To: Mayor and City Council

From: Bradford D. Townsend, Planning and Zoning Director

Date: July 20, 2009

RE: Parkway Village (PV09-01) and Hardship Variance Requests

- PV09-01
- 50ft Undisturbed Buffer
- 75ft Impervious Buffer
- Streams
- Parkway Village Boundary

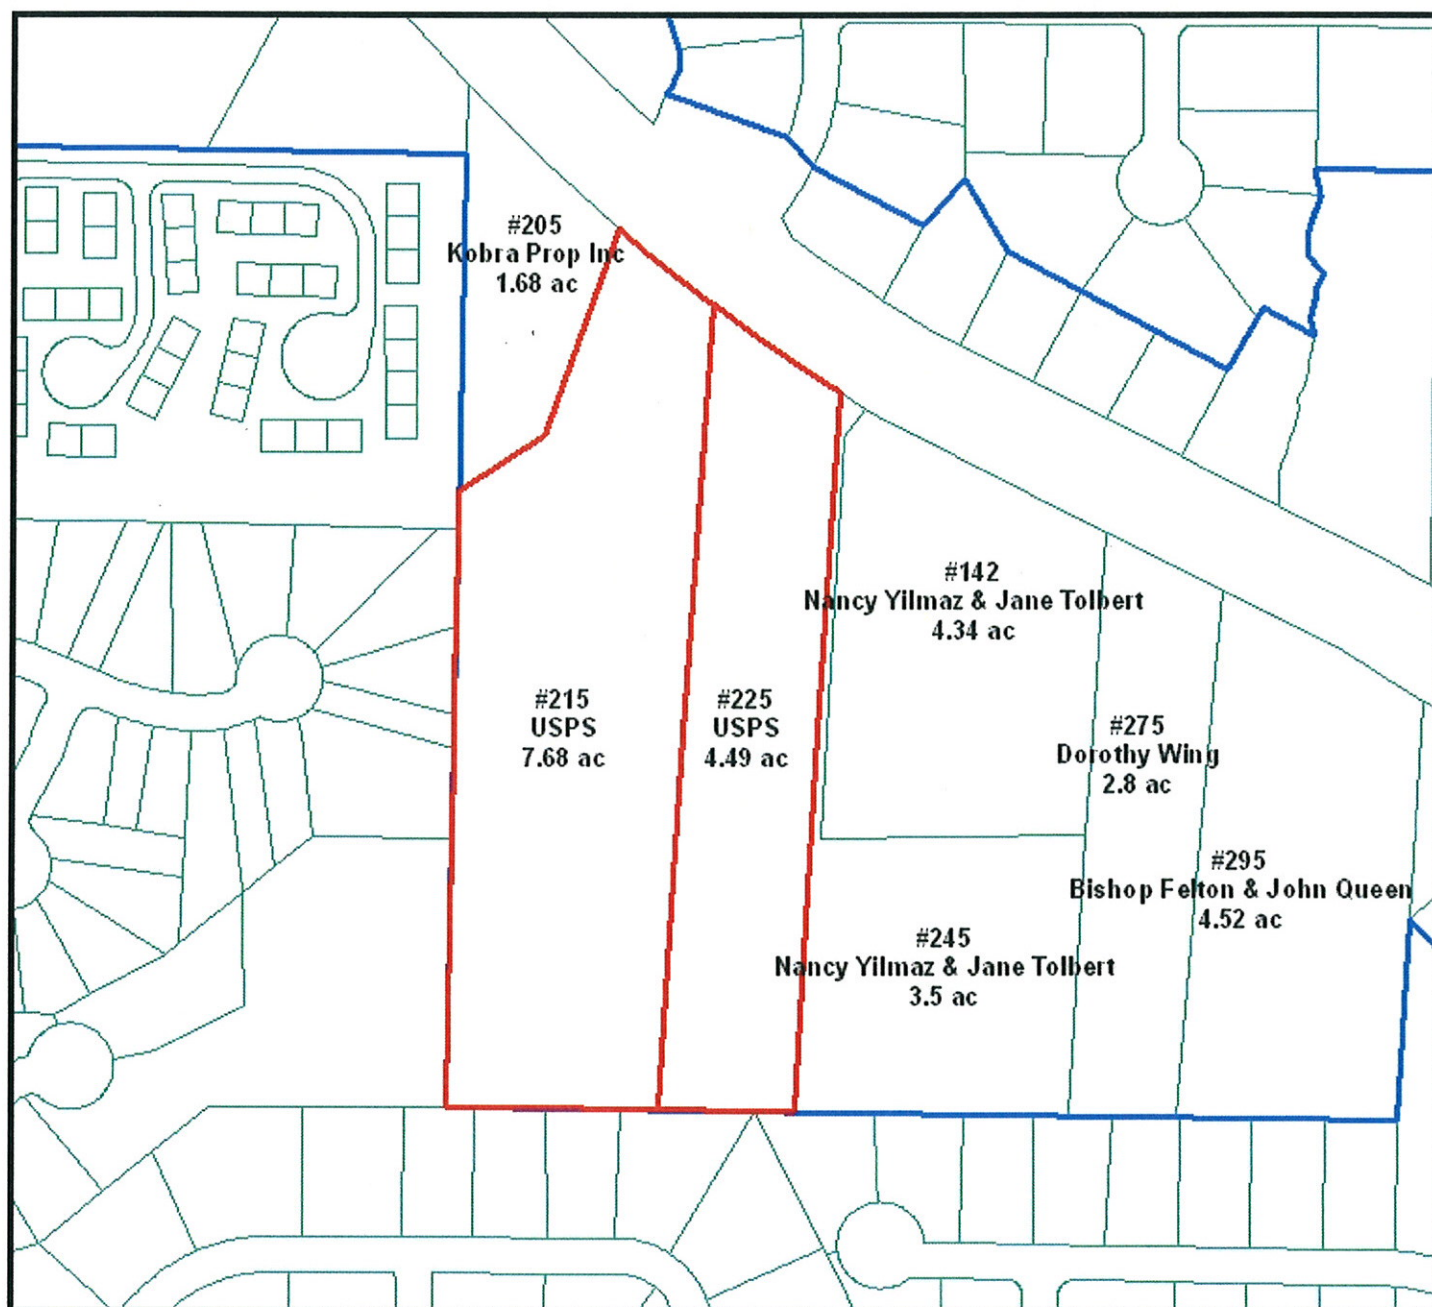
As previously noted, Hog Waller Creek goes across the northern portion of the proposed development adjacent to SR 92. Since this stream is classified by the City of Roswell as a

flowing stream, it has a 50' undisturbed buffer and a 75' impervious buffer. The applicant is requesting a stream buffer variance in order to develop the site according to their needs which includes removing all existing vegetation in the 50' buffer except the three (3) specimen trees. A portion of the paved asphalt is also within this undisturbed buffer. Likewise, a portion of the paved asphalt and fuel canopy is located within the 75' impervious buffer as well.

The Public Works/Environmental Department is opposed to granting variances to the stream buffer ordinance for this use on this property. This property drains to Hog Wallow Creek which is listed as an impaired stream. Stream buffers are recognized to be critical for stream health. The plan put forth by the applicant removes the majority of the undergrowth and many of the trees within the 50-foot undisturbed stream buffer. The plan installs impervious materials in the majority of the 75-foot no-impervious buffer. This plan to "re-work" the buffer and eliminate the impervious buffer has serious negative impacts on overall stream health.

1. Impact of the proposed development on the existing stream
2. Encroachment into the 75' impervious buffer
3. Construction of the retaining walls and drive areas in the 50' stream buffer
4. Severe change in the existing topography of the site.

8. The underground storage tanks shall be moved out of the 75-foot no-impervious buffer.
9. Grading plan must ensure that all stormwater that flows from any parking area flows to the hydrodynamic device prior to entering the detention pond.
